**DEVELOPMENT REVIEW BOARD MEETING
APRIL 12, 2021
6:30 PM**

- A. Resolution No. 388. Canyon Creek 8-Lot Subdivision: Scott Miller, SAMM-Miller LLC – Applicant for William Z. Spring and Fallbrook, LLC – Owners.** The applicant is requesting approval of a Comprehensive Plan Map Amendment from Residential 0-1 Dwelling Units per Acre to Residential 4-5 Dwelling Units per Acre, a Zone Map Amendment from Residential Agriculture-Holding (RA-H) to Planned Development Residential 3 (PDR-3) and adopting findings and conditions approving a Stage I Master Plan, Stage II Final Plan, Site Design Review, Type C Tree Plan, Tentative Subdivision Plat, and Waiver for an 8-lot residential subdivision located at 28700 and 28705 SW Canyon Creek Road South. The subject site is located on Tax Lot 6400 and a portion of Tax Lot 3800 of Section 13BD, Township 3 South, Range 1 West, Willamette Meridian, City of Wilsonville, Clackamas County, Oregon. Staff: Philip Bradford

**DEVELOPMENT REVIEW BOARD
RESOLUTION NO. 388**

Exhibit A1
Staff Report
Canyon Creek Phase 3 Subdivision – 8 New Residential Lots

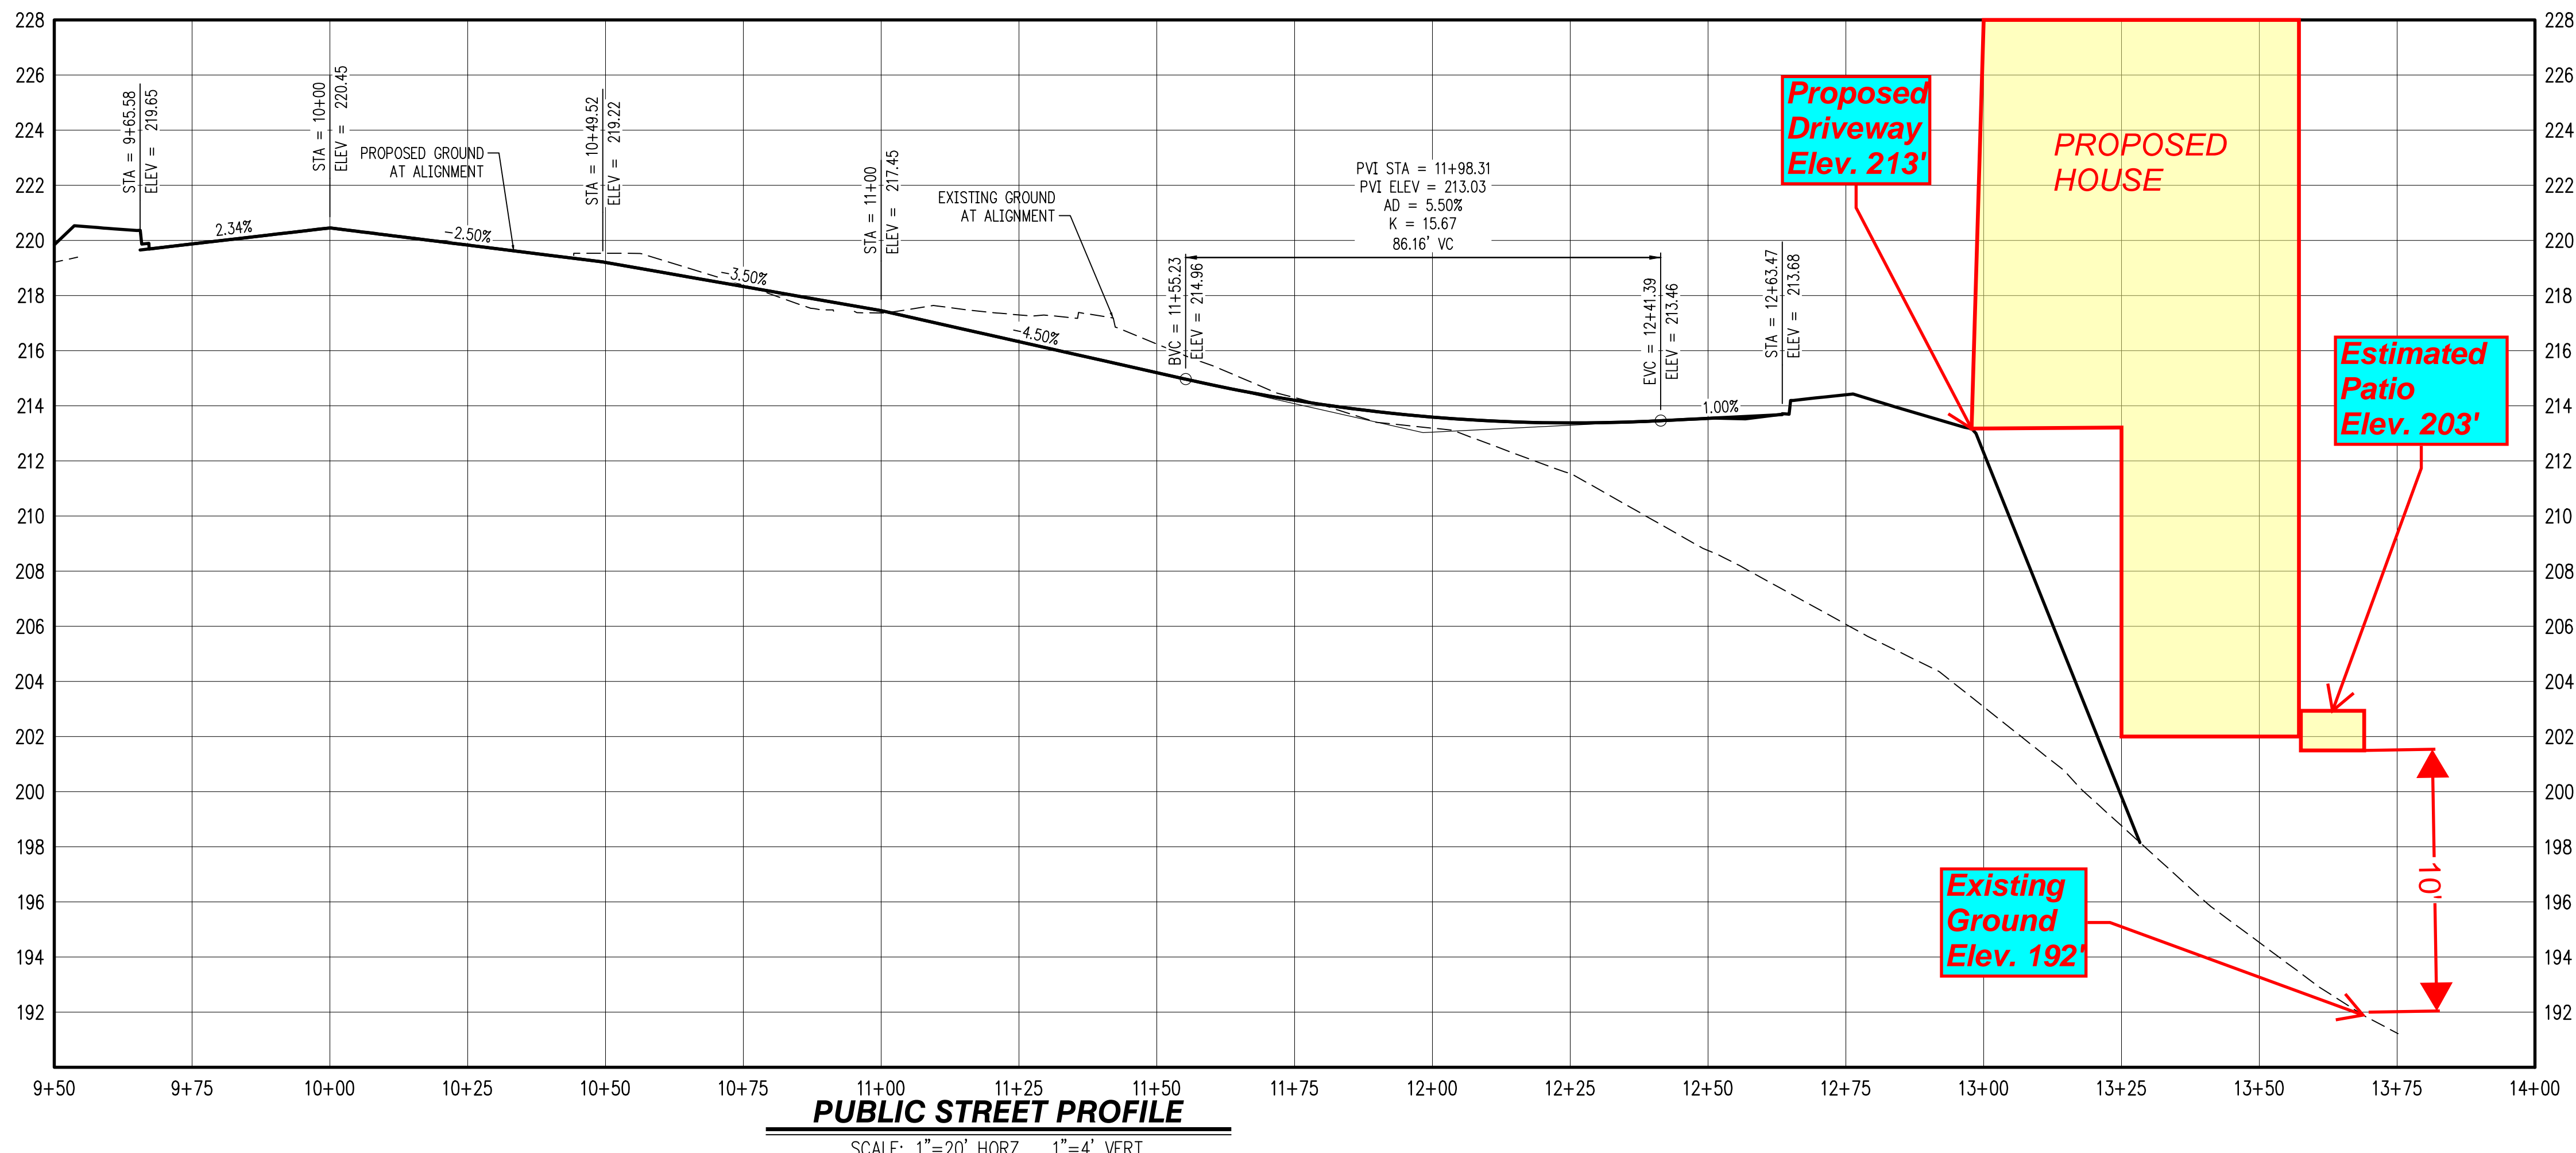
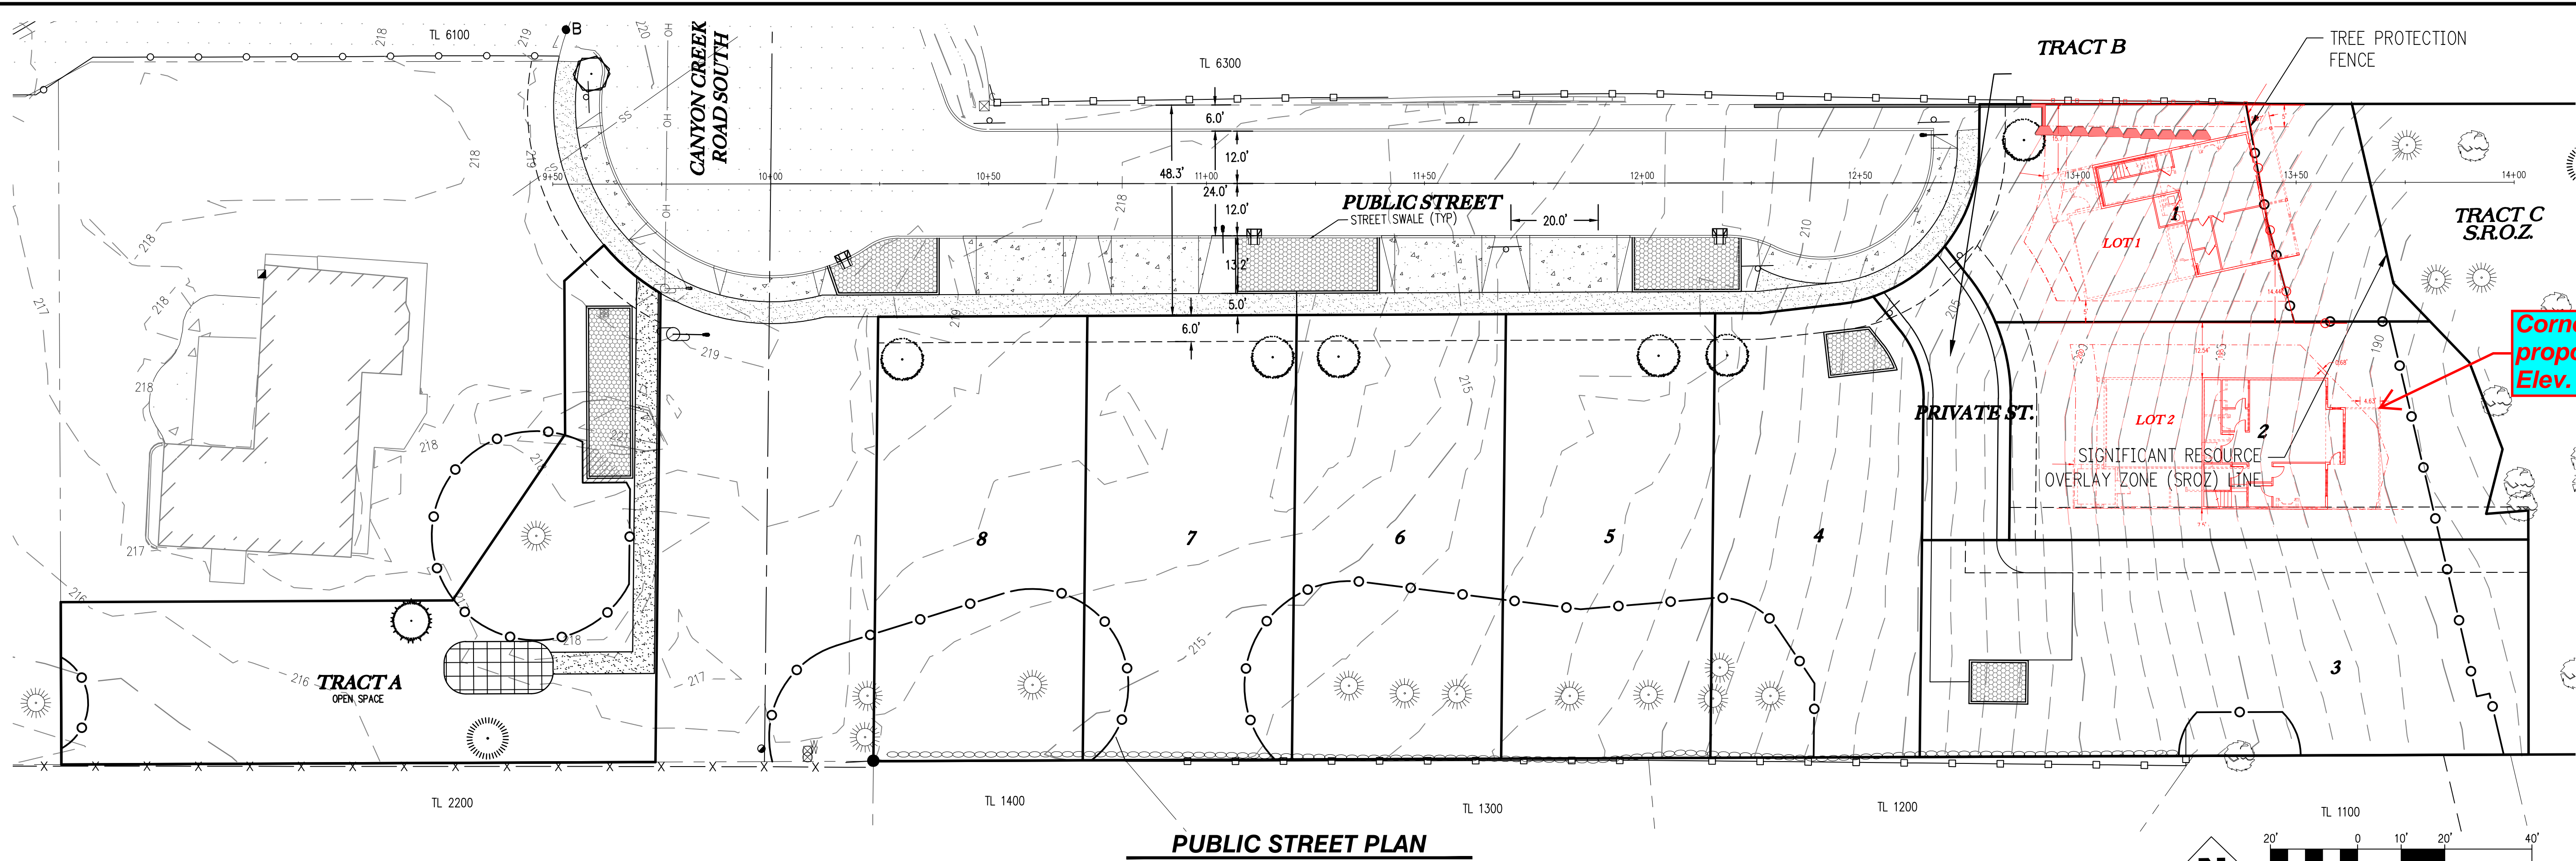
Between lots 2 and 3 is a new proposed 15-foot storm easement, which further reduces the available width for homes in this area. Lot 3 is the most difficult to access. It is at the end of the proposed private street. Lot 3 also has the most impact on existing homes in our Vlahos neighborhood. The proposed home is only a few feet away from the patio of a home in Vlahos! With the removal of trees, there will be absolutely no privacy. Instead of looking at beautiful 50-foot trees they will now have a three-story house towering over them. The loss of home value is drastic and irreplaceable. Moving forward with this plan effectively ruins their home.

Part of the area of lot 3 could instead be preserved as natural area. Or even have benches near the already beautiful trees. We have noticed that a small grove of trees was saved for this purpose in one of the already developed acres. Why not do that again?
